Mount Emerald Wind Farm Traffic Impact Assessment

Technical Note 2 - Traffic Impact Assessment Engineering Response

Traffic Impact Questions 23 to 26 | Rev 1

Response to Ministerial Call-In Information Request - TRAFFIC

Figure 4-1 Estimated total number of workers during construction stage (24 months)

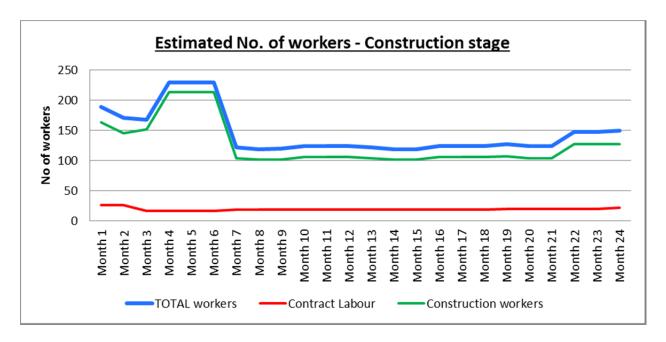
Provide further information on how staff travel to site can be managed in a way that will allow the maximum number of staff vehicles to remain below 30 vehicles per day as indicated in the Traffic Impact Assessment.

Figure 4-1 outlines the total estimated workers for the project during the construction phase (blue line) which includes the estimated construction-related workers (green line) and the estimated skilled/unskilled contract labourers (red line).

The estimated maximum numbers of workers expected to be on site during month 4 to month 6 of the construction phase is approximately 229. Of these 229 workers, 16 workers will be contract skilled and unskilled labourers and are expected to arrive and depart the site via individual or shared private vehicles.

Based on the assumptions above, the maximum number of trips generated by the estimated number of workers during the construction is expected to be 16 vehicles per day, which comprise eight 30-seater buses and eight light vehicles. To provide a robust assessment, a nominal 10 additional vehicles per day has been added to allow for unscheduled visits, deliveries, private vehicles, miscellaneous tasks, and for construction workers who need to bring their own vehicles with trade specific tools. This makes an estimated total of 26 vehicle movements at the site per day.

Appendix A. Multi-Combination Routes in Queensland: selection of maps with proposed routes

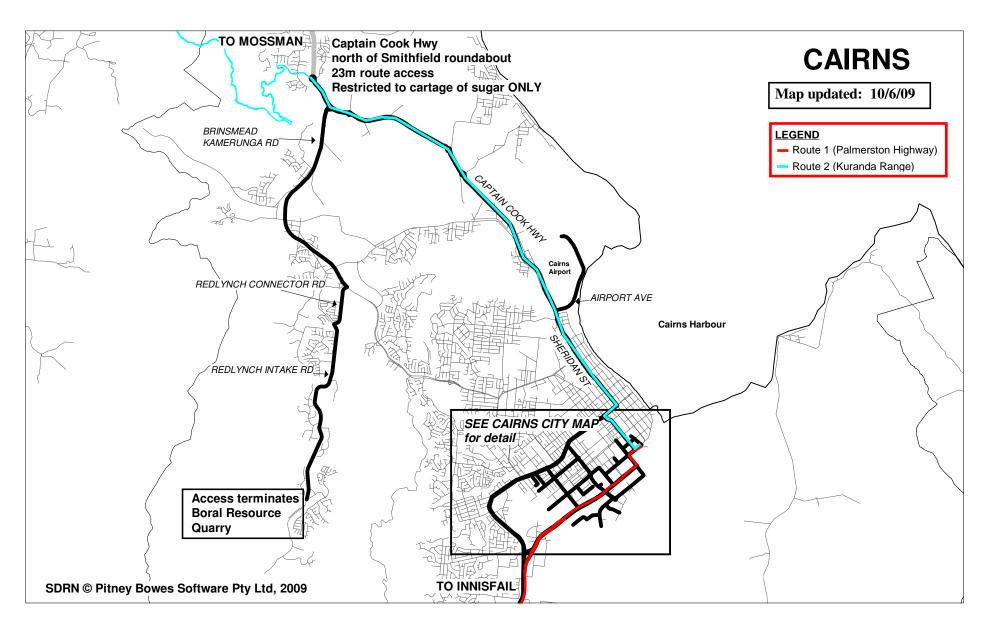
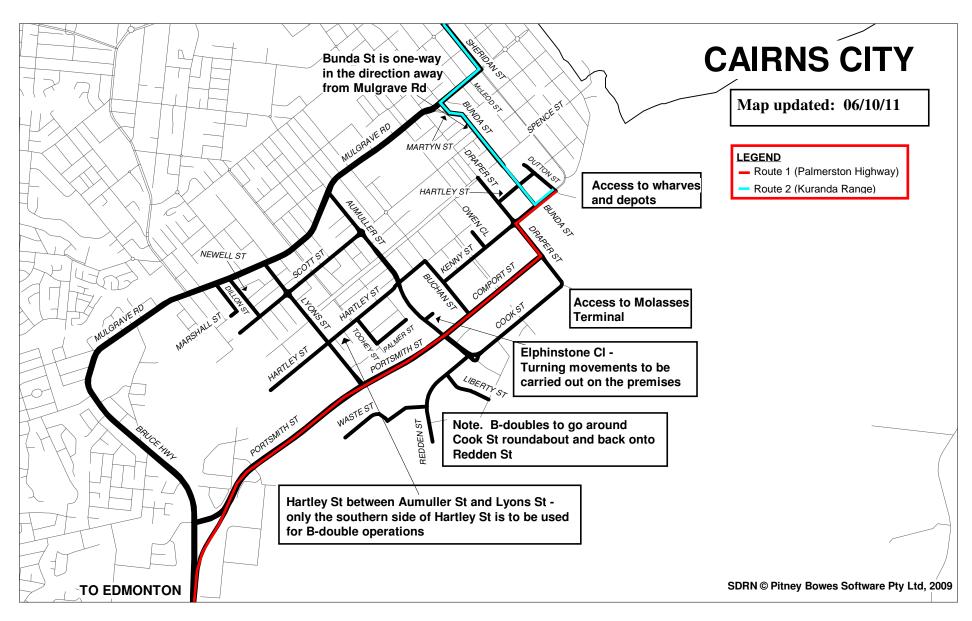
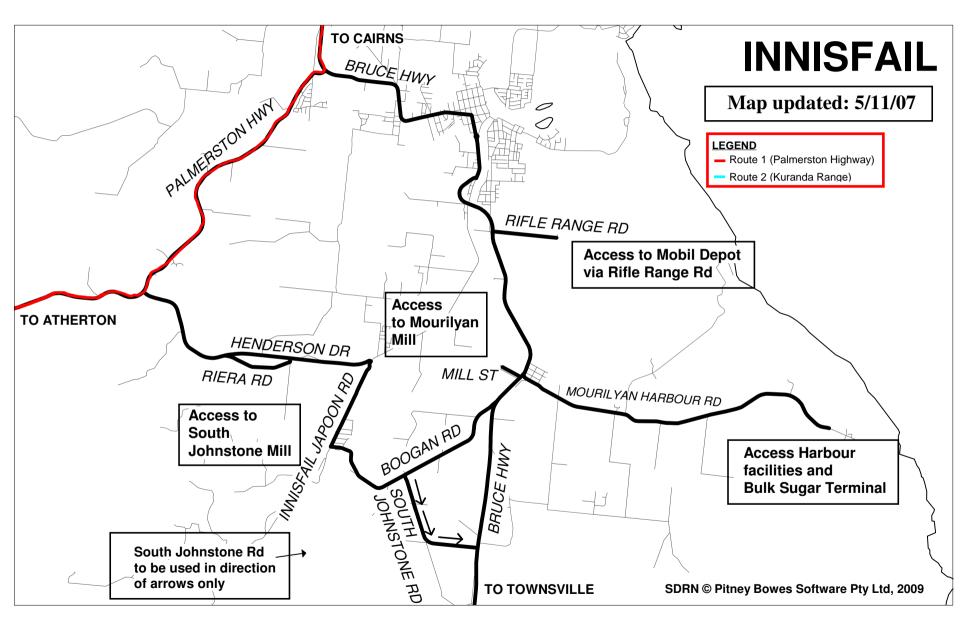
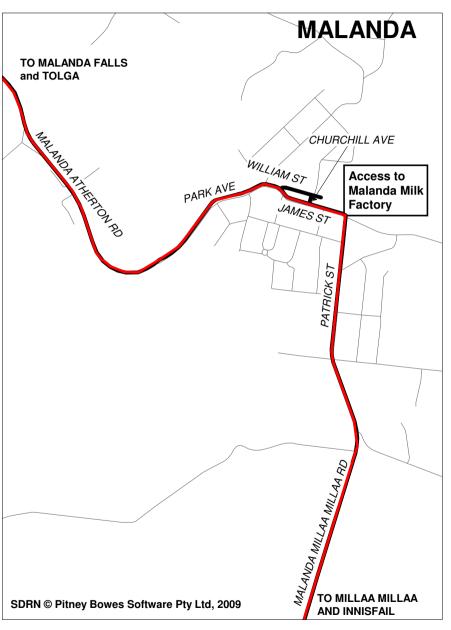
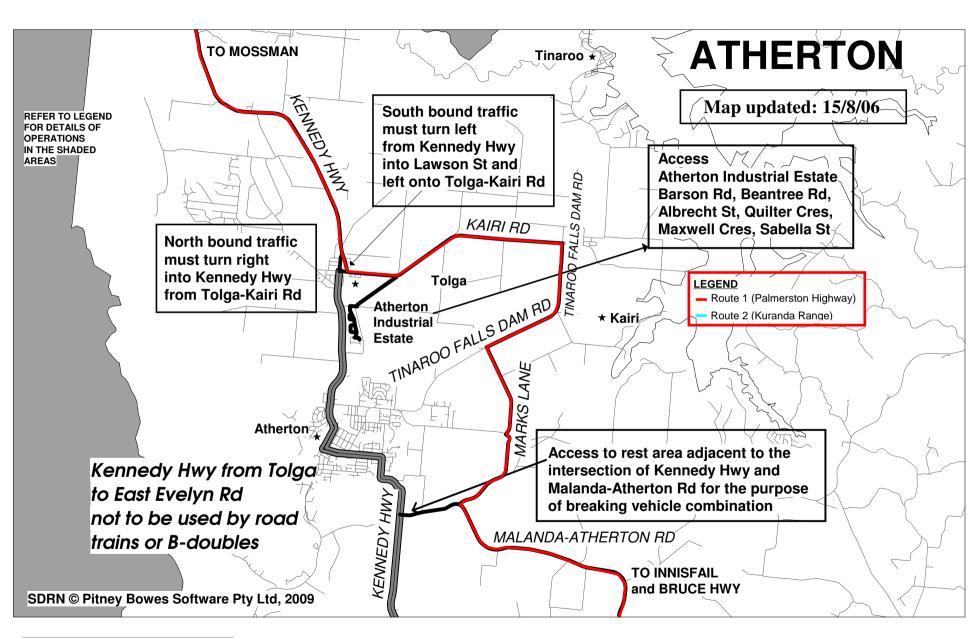
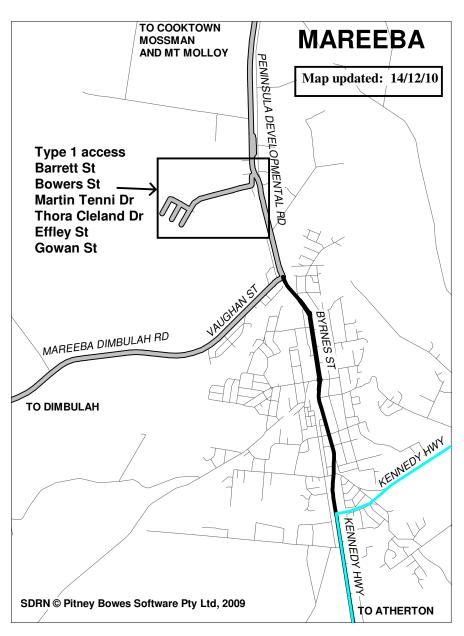
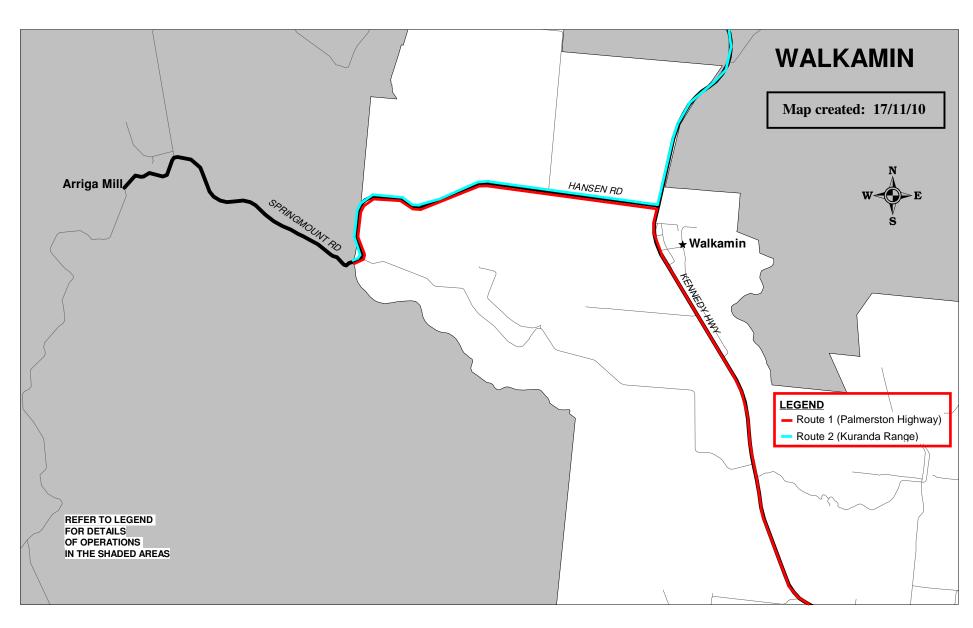
Provide a clear description of all possible access routes (in their entirety) to the site for oversized vehicles. This should include at least a high level identification of constraints along the network and identification of measures that would be put in place to allow State Government and council to assess these impacts.

Two possible access routes for oversized vehicles were analysed in their entirety from Cairns Port to Mount Emerald. Maps detailing these two routes have been included in Appendix A of this report. A summary of each route is detailed in Table 2-1 below:

It is recommended that a horizontal and vertical (crests and sags) geometry check, in addition to checking the vehicle envelope, is completed for the full length of each route. Due to their generally narrower road widths, it is noted that the horizontal geometry of Council-controlled roads should be checked. Horizontal geometry limits and overhanging rainforest canopy experienced on the Kennedy Highway (Cairns – Mareeba) via *Route* 2 will not permit the turn paths and the large envelope exhibited by the B-Doubles when transporting larger components (such as the rotor blade, hub, machine house components and steel sections). Contrary to this, there may be the potential for vehicle configurations with a smaller vehicle envelope and tighter turn path to utilise *Route* 2 when transporting smaller components under a permit as it is significantly shorter in comparison to *Route* 1.

Any areas requiring a temporary lane closure must comply with the Far North Queensland – Table of Allowable Lane Closures (TALC) and will require an approved Traffic Guidance Scheme and Traffic Management Plan prior to implementation. It is also suggested that a Community Liaison Officer is utilised to communicate lane closures with the relevant Local Authorities; local business or organisations which may be affected; and the general public. It should be noted that these issues are not restricted to the locations noted above and the following issues may be experienced along the entire route:
